SERVICE DIRECTIVE BULLETIN NO. T-064

1. SUBJECT: Tailcone Bulkhead Inspection
2. MODEL: 480, 480B
3. EFFECTIVITY: All S/N
4. BACKGROUND:

Figure 1. Crack Inspection Areas

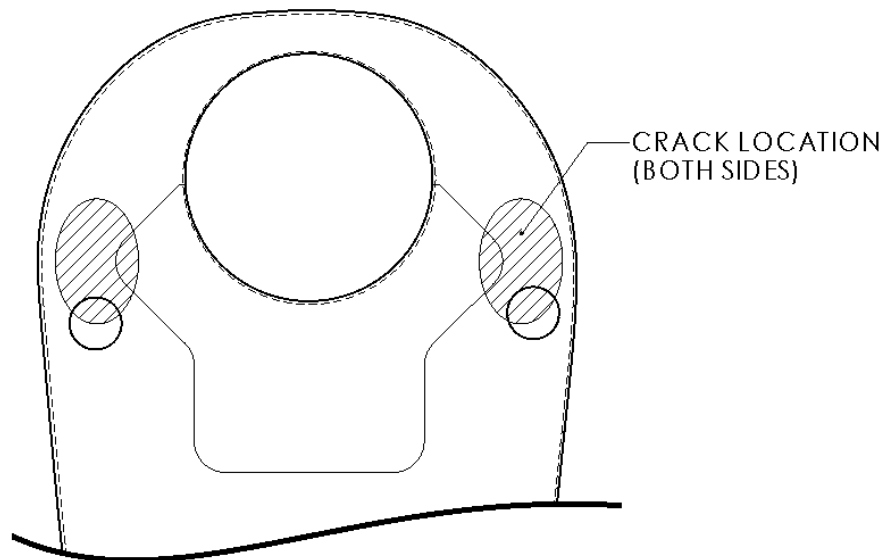
- 5.1 Within the next 10 flight hours, perform a visual inspection of the bulkhead.
 - 5.1.1 Using a suitable light source, inspect the bulkhead in the areas shown in Figure 1.

5.2.3 Using a suitable light source and a mirror as required, inspect the interior surface of the bulkhead for cracks in the areas indicated in Figure 1.

5.2.4 Using a 10-power magnifying glass and a suitable light source, inspect the exterior surface of the bulkhead for cracks in the areas indicated in Figure 1.

Figure 2. Crack in Aft Tailcone Bulkhead (Example 1)

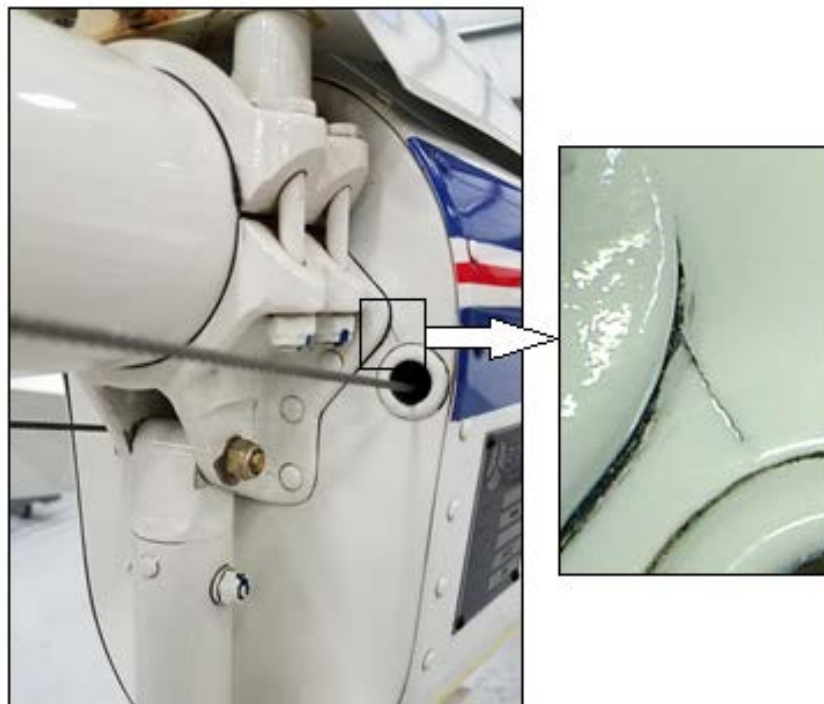
- 5.1.2 Examples of a cracked bulkhead are shown in Figure 2 and Figure 3. In both examples, there is a crack on the right side near the lobe of the lower clamp assembly.

- 5.1.4 If a crack is detected, stop drill ($\varnothing.094$ through the bulkhead) both ends of the crack. If one end of the crack is obscured by the grommet, there is no need to stop drill the hidden end of the crack. The bulkhead must be inspected and repaired in accordance with paragraphs 5.2 and 6 at or before the next 100 hour/annual inspection.

Figure 4. Aft Bulkhead Doubler Installation

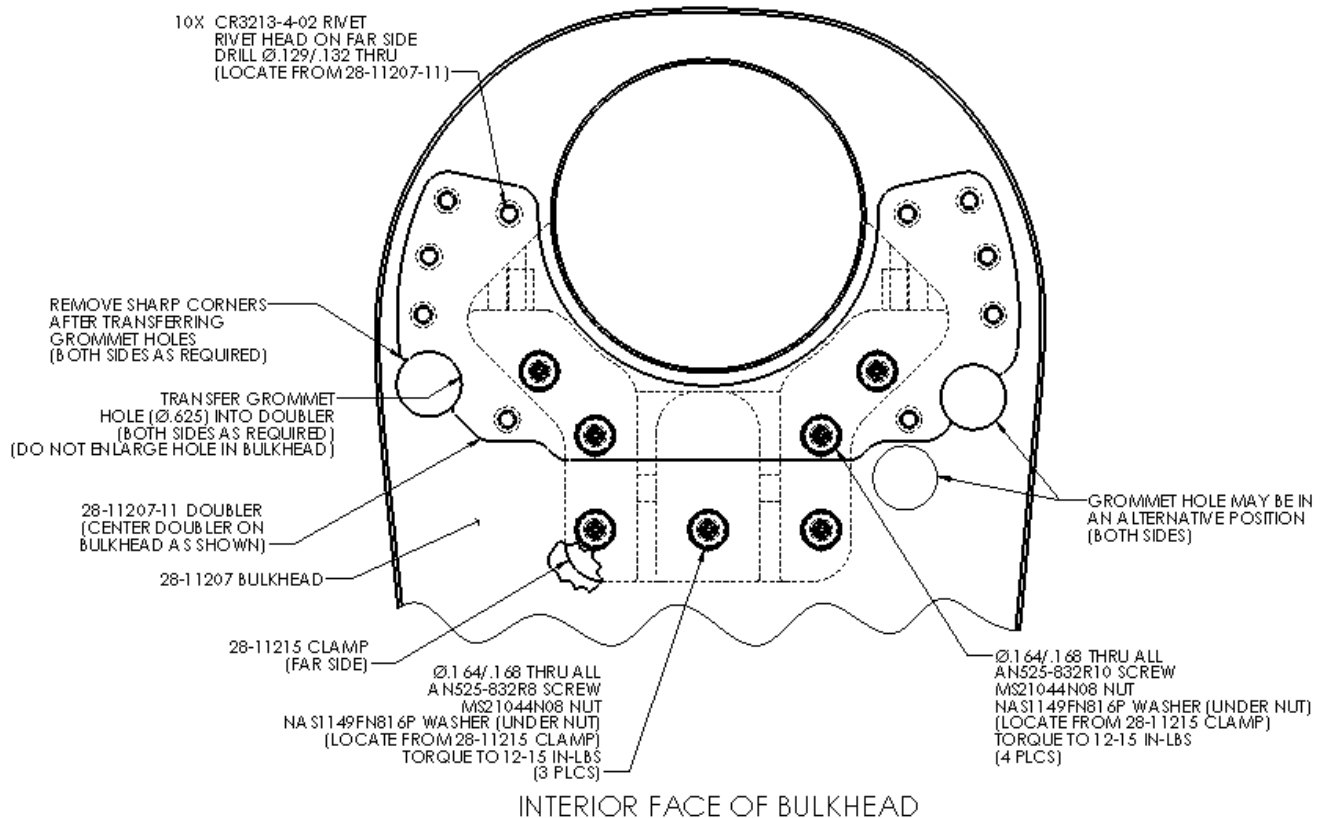
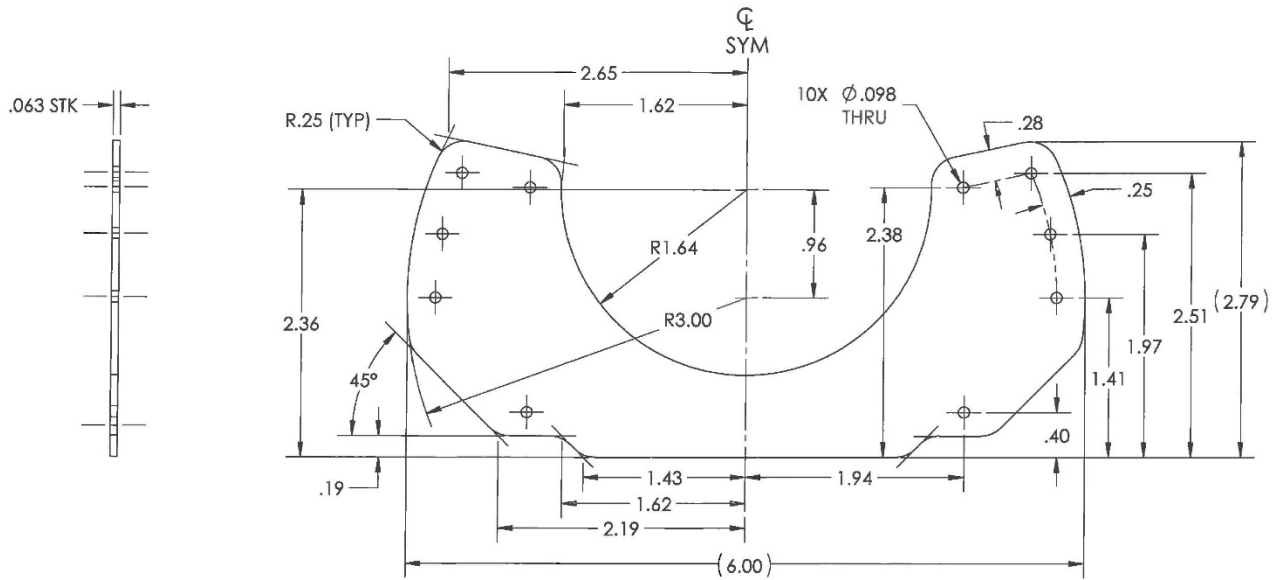
6.2.1 Install P/N 28-11207-11 doubler (Figure 4).

- 6.2.1.1 Remove grommets from tail rotor cable holes.
- 6.2.1.2 Using a Sharpie™ marker or equivalent, mark one face of the doubler “aft” to maintain the orientation of the doubler throughout this process.

- 6.2.1.3 Center the doubler on the exterior face of the bulkhead.
- 6.2.1.4 Match drill the rivet holes \varnothing .097/.101 (#40 drill bit) from the doubler to the bulkhead (10 plcs).

- 6.2.1.5 Position the doubler on the interior face of the bulkhead. Line up the rivet holes to match the drilled holes in the bulkhead.
- 6.2.1.6 Cleco the doubler in place. Match drill the clamp rivet holes \varnothing .164/.164 (#20 drill bit) from the bulkhead to the doubler (4 plcs).

- 6.2.1.7 Enlarge the holes for mounting the P/N 28-11215 clamp to \varnothing .164/.168 (#19 drill bit) (7 plcs).
- 6.2.1.8 Enlarge the rivet holes for mounting the P/N 28-11207-11 doubler to the bulkhead (\varnothing .129/.132, #30 drill bit) (10 plcs).
